SUNSHINE COAST REGIONAL DISTRICT

AMENDMENT NO.#2

Request for Proposal No. 2537007

Well Redevelopment for Chaster Well Improvements (Phase 2)

"b) Figures:

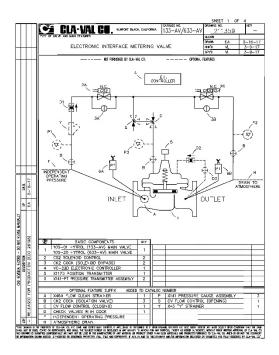
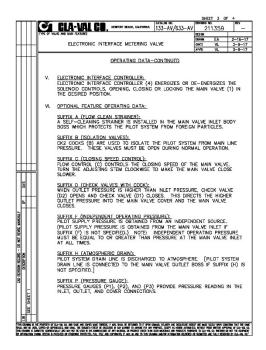
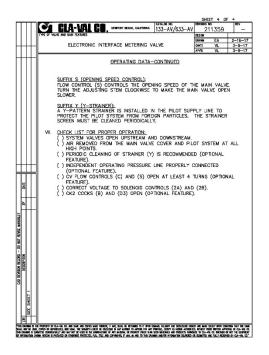
Item 4. Appendix 1 Specifications- Division 40 Process Interconnections Section 400567 Electronic –Control Valve and Valve Controller Item 3.0 Electrical Flow Control, 3.4 Manufacturer, 4. Pilot control System

Add new item:

I. ELECTRONIC INTERFACE FEATURE. SOLENOD CONTROLS (24) AND (28) ARE DIRECT ACTING 2 - WAY SOLENOD THAT ON THE PERTURN WHEN THE CONSTRUCT ACTING 2 - WAY CONTROL THAT ON THE PERTURN WHEN THE CONSTRUCT ACTING PARAGRAPHS DESCRIBE THE OPENING AND CLOSING CYCLES OF TH VALVE (1).					
			DENNIQ: WINT THE ELECTRONIC INTERFACE CONTROLLER (4) ENERGZES SOLENDO CONTROL (28), SOLENDO CONTROL (2A) IS DE-ESTERGIZED. "HIS RELEVES UNTL THE ELECTRONIC INTERFACE CONTROLLER (4) DE-INTERGZES SOLENDO CONTROL (28), LOCIMON THE WAIN VALVE (1) INTERGZES SOLENDO CONTROL (28), LOCIMON THE WAIN VALVE (1) INTERGZES SOLENDO				
DATE			$ \begin{array}{llllllllllllllllllllllllllllllllllll$				
8		Т.	MANUAL BYPASS FEATURE:				
\$	SEE SHEET 1		<u>DPENING:</u> MANUALLY OPEN CK2 COCK (3B) AND CLOSE CK2 COCK (3A). THIS BYPASSES SOLENGID CONTROL (2B), OPENING THE MAIN VALVE (1).				
			LOCKED: MANUALLY CLOSE CK2 COCKS (3A) AND (3B). THIS LOCKS IN MAIN VALVE (1) IN AN INTERMEDIATE POSITION.

KUL-RS			CLOSING: MANUALLY OPEN CK2 COCK (3A) AND CLOSE CK2 COCK (38). THIS BYPASSES SOLENOID CONTROL (2A), CLOSING THE MAIN VALVE (1).				
W011-R05630		II. <u>DBESSURE TRANSMITTER</u> , PRESSURE TRANSMITTERS (6A) AND (6B) SENSE THE PRESSURE AT THE MAIN VALVE (1) INLET AND OUTLET RESPECTIVELY. THIS TRANSMITS A SIGNAL TO THE ELECTRONIC INTERFACE CONTROLLER (4) WHICH USES THIS SIGNAL TO DISPLAY THE FLOW RATE THROUGH THE WAIN VALVE (1).					
		IV.	4. <u>POSITION TRANSMITTER:</u> POSITION TRANSMITTER (5) TRANSMITS A POSITIONAL SIGNAL FROM THE MAIN VALVE TO THE ELECTRONIC INTERFACE CONTROLLER (4).
